## *Mask Set Errata 1*

# **PC9S12H256 Microcontroller Unit**

- 0K78X mask of the PC9S12H256 and PC9S12H128

**Work-around**      None**SELF CLOCK FREQUENCY TOO HIGH****MUCTS00700**

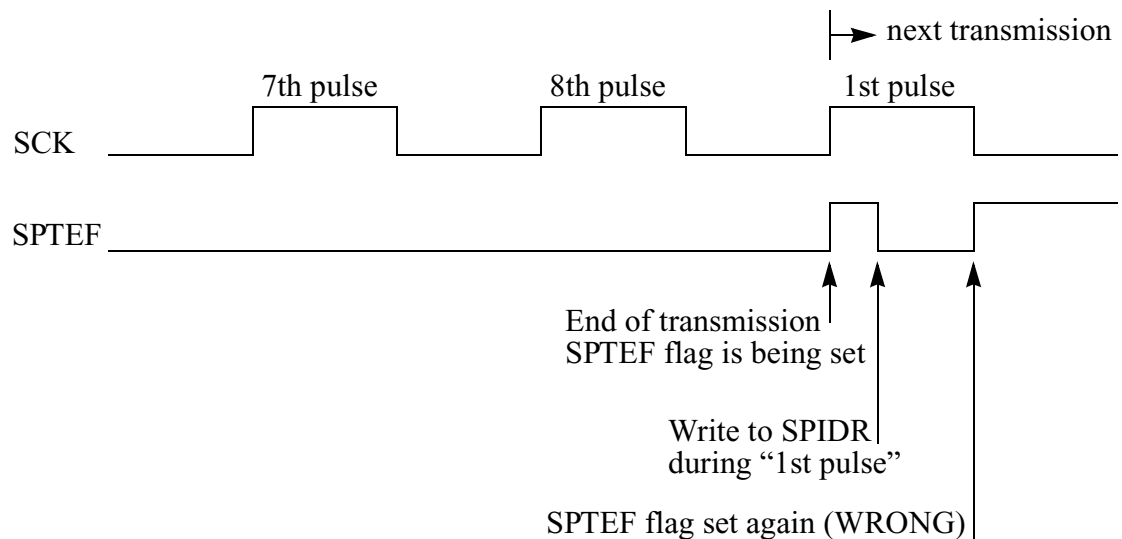
The self clock mode frequency can exceed the maximum specified value. The maximum possible self clock mode frequency is 10.0MHz. This affects three additional spec values. 1. The clock quality check may fail for EXTAL frequencies below 800kHz. Therefore the crystal oscillator frequency range minimum value is 1.0MHz. 2. The PLL may not lock to the minimum specified PLL frequency of 8.0MHz. Therefore the VCO locking range minimum value is 12.0MHz, which corresponds to a 6.0MHz bus frequency. 3. The clock quality check time-out minimum value is 0.25s.

- Work-around**
1. Instead of 500kHz use a 1MHz quartz, resonator or oscillator.
  2. Only synthesize PLL frequencies from 12MHz to the maximum specified value. 12MHz PLL frequency corresponds to 6MHz bus frequency.
